July 15, 2024

RE: Letter of Determination for Minor SPMP Change & Final Site Plan & Appearance Review
for RoseArts Phase 1, 5155 Rosamond Dr., Orlando, FL (Parcel ID #08-22-29-7746-31-
000) **DET2024-10001**

I have reviewed your Letter of Determination request relative to a Minor Change to the approved Specific Parcel Master Plan (SPMP) and Final Site Plan and Appearance Review approval of the proposed RoseArts Phase 1, to be located on a 38.5+ -acre parcel on the north side of Lake Breeze Dr. and southeast side of Rosamond Dr., Orlando, FL. You have provided updated site and landscape plans and updated building elevations for the proposed Phase 1 mixed use development. You also provided a very detailed 8-page project narrative, explaining the changes since adoption of the RoseArts PD and Phase 1 Specific Parcel Master Plan (SPMP).

Transportation – Approved 2022 SPMP

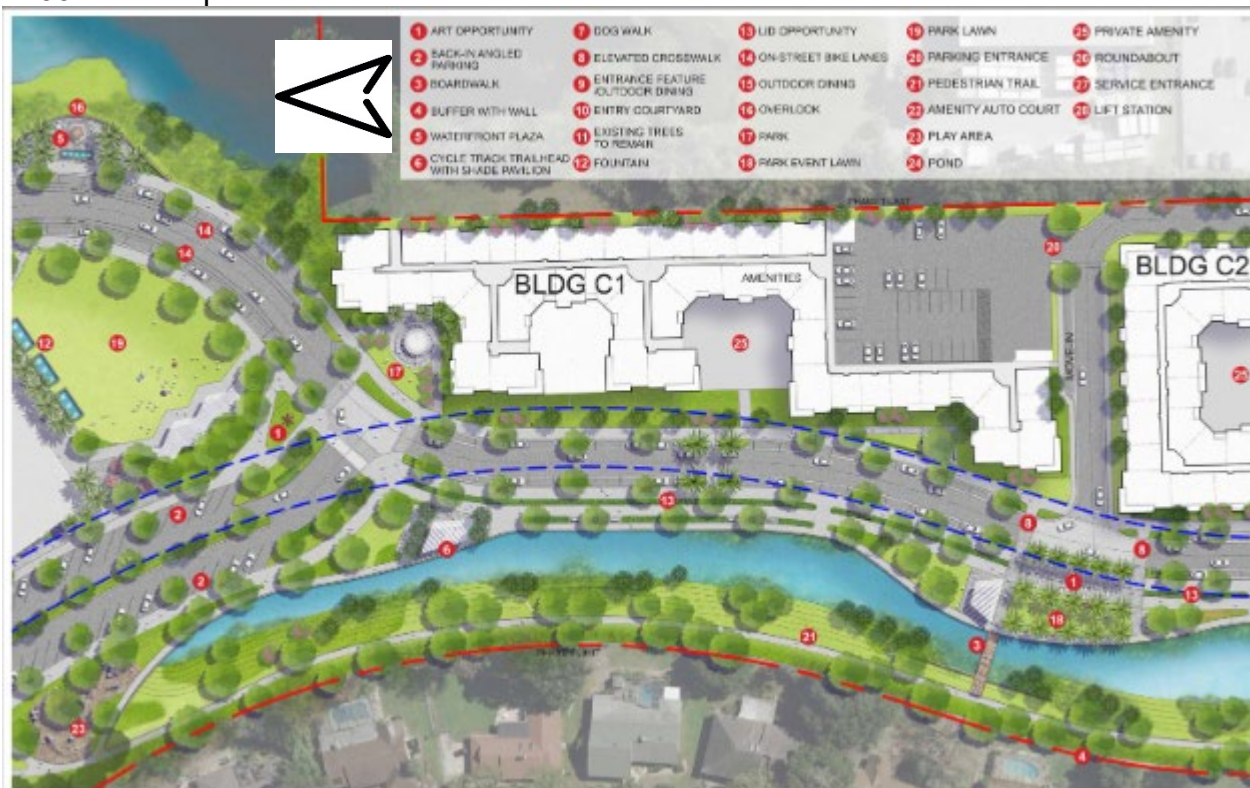
Transportation – The site plan for phase 1 of the development includes a shift of the primary access roadway along Rosamond Dr. from the eastern end of the project, as approved in the PD, to the center roadway. As noted in Figure 2 of the Major Thoroughfare Plan (MTP), LDC Section 61.214, a minimum separation of 660 ft. is required for full access intersections, 330 ft. for directional access and 125 ft. for right-in/right-out on Access Class C roadways with raised medians; Rosamond Dr. has an Access Classification of Class C. This project is seeking separation exemption for the project intersections along Rosamond Dr.

The proposed access modifications do not alter the location of the street intersections but rather shift the type of access management along Rosamond Dr. The location of buildings within the site have been moved to accommodate constraints on stormwater structures and fill, which caused the shifting of the primary access street. The final, updated traffic study analyzing the impact of the access modifications was provided by the applicant in June 2024 and reviewed by city staff; based on the updated traffic study, all proposed intersections are shown to operate at an acceptable level of service.

Therefore, the alternative intersection locations are approved, subject to the following conditions which are being incorporated into DET2024-10001 (copied into the conditions beginning on page 4):

2. The eastern access point (closest to N. Orange Blossom Trl.) is no longer a roadway and must be constructed and maintained as a driveway and not a roadway. The other two access points must be constructed and dedicated as full roadways.

3. The driveway and median adjacent to the eastern access point must be modified to restrict movements coming from the new roadway to right-in/right-out only (from/onto Rosamond Dr.).

4. The median at the new central access point on Rosamond Dr. must be modified to include a 120 ft. long exclusive westbound, left-turn lane with a 50-foot taper.
